CENTERVILLE CITY PLANNING COMMISSION AGENDA

E. COMMISSION BUSINESS
- 7:10 1. **PUBLIC HEARING | MAVERIK INC. | CORNER OF PARRISH LN & 1250 WEST**
 Consider proposed Conditional Use Permit for a “Gasoline Service Station” and Final Site Plan for a Maverik Convenience Store, on property located at the corner of Parrish Lane and 1250 West, in the Legacy Trail Apartments Development. Don Lilyquist, Maverik Inc., Applicant

APPLICATIONS: FINAL SITE PLAN, PHASE/LOT ONE (1), LEGACY TRAIL
APARTMENTS PROJECT
CONDITIONAL USE PERMIT FOR GASOLINE SERVICE
STATION

FINAL SITE PLAN REVIEW & PLANNING STAFF ANALYSIS **DEVELOPMENT PHASE APPROVAL/LIMITED TO PHASE 1 REVIEW**

PROPOSED SITE PLAN

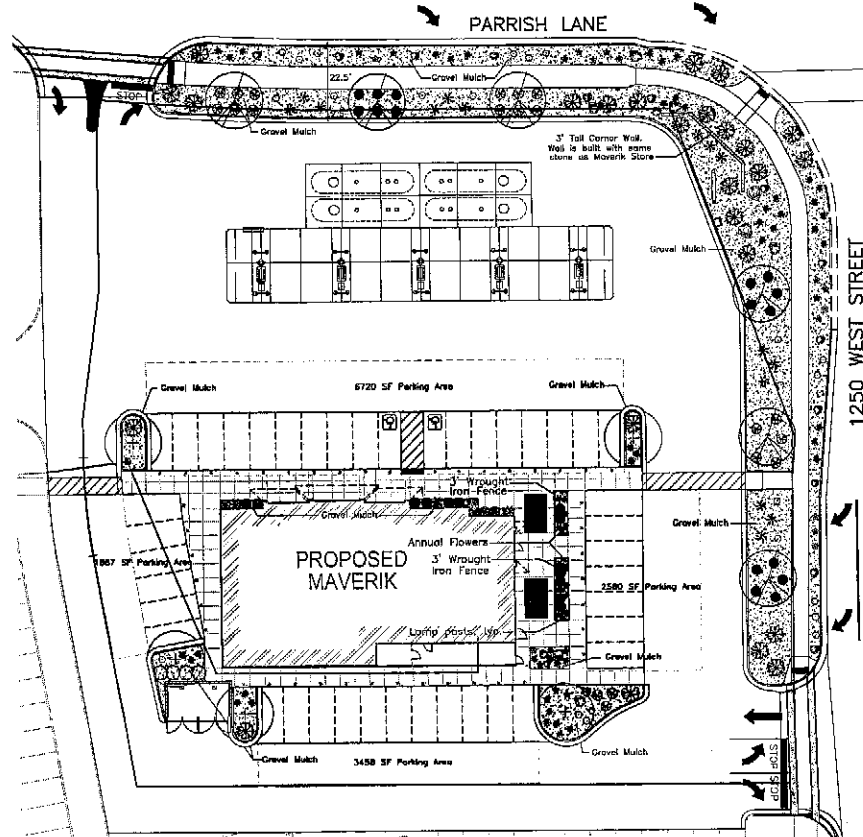
Staff Comment: The final plans address the pedestrian crossings for each entrance. However, the pedestrian access path from 1250 West to the storefront is absent of meeting the requirement and depicts a painted stripe style path.

4. The Landscaping Plan must be revised, as follows:
- i. *Plans to be prepared by a licensed landscape architect*
Staff Comment: The landscape plans are stamped by a licensed engineer, rather than a landscape architect.

- ii. *Meet the required 10% on-site landscaping*
Staff Comment: The plans indicated only 7% on-site landscaping. The applicant is seeking a "Waiver of Strict Compliance," which is addressed later in this report.

- vii. *Provide the required 17-18 street trees*
Staff Comment: The landscaping plans are not compliant with the requirement (6 of 17).

6. The final plans shall address the installation of the required decorative pedestrian access path from 1250 West to the storefront.
7. The site landscaping plans shall be stamped by a licensed landscape architect.

8. The landscaping plans shall be corrected to be compliant with the street tree frontage requirement of 17 trees and deemed acceptable by City staff.
9. At the request of the Parks and Recreation Committee, the City and Maverik may negotiate a partnership to construct a trailhead/bike rest area to function as the required site feature. If this does not happen, the applicant shall return to the Planning Commission and present an alternative design for Commission approval.

DATE	
10/09/2015	
PERMIT SET	
PROJECT NUMBER 18	
FILE	
DRAWING BY 19	
CHECKED BY	
50317 As indicated	
CANOPY ELEVATIONS

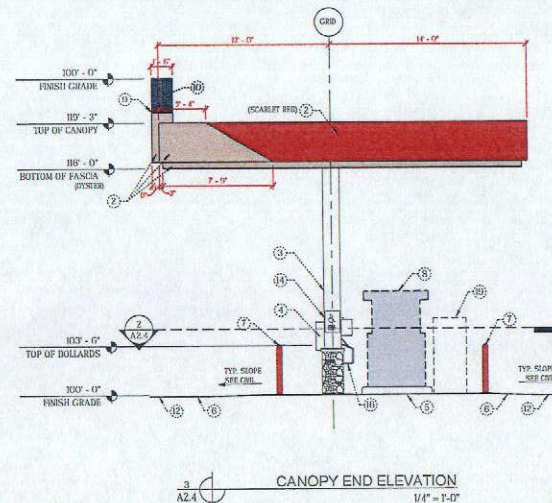
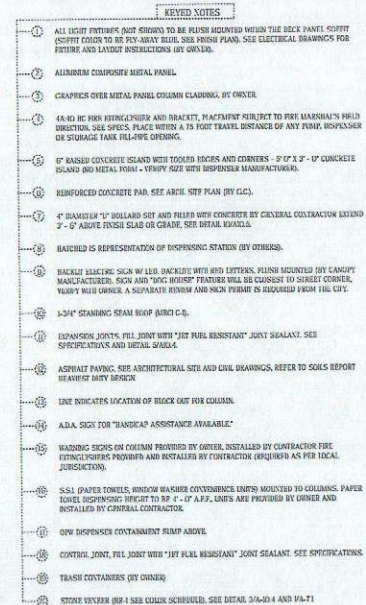
Staff Comment: The colors of the canopy design appear to match the main building. However, approved amended theme maintained the requirement to utilize a brick or rock-style wainscot for all buildings. The plans for the canopy depict a “graphic wrap” pole style support for the canopy. Staff recommends that the Commission require a brick or rock base element for the poles, as has been done for other canopy structures (see example).
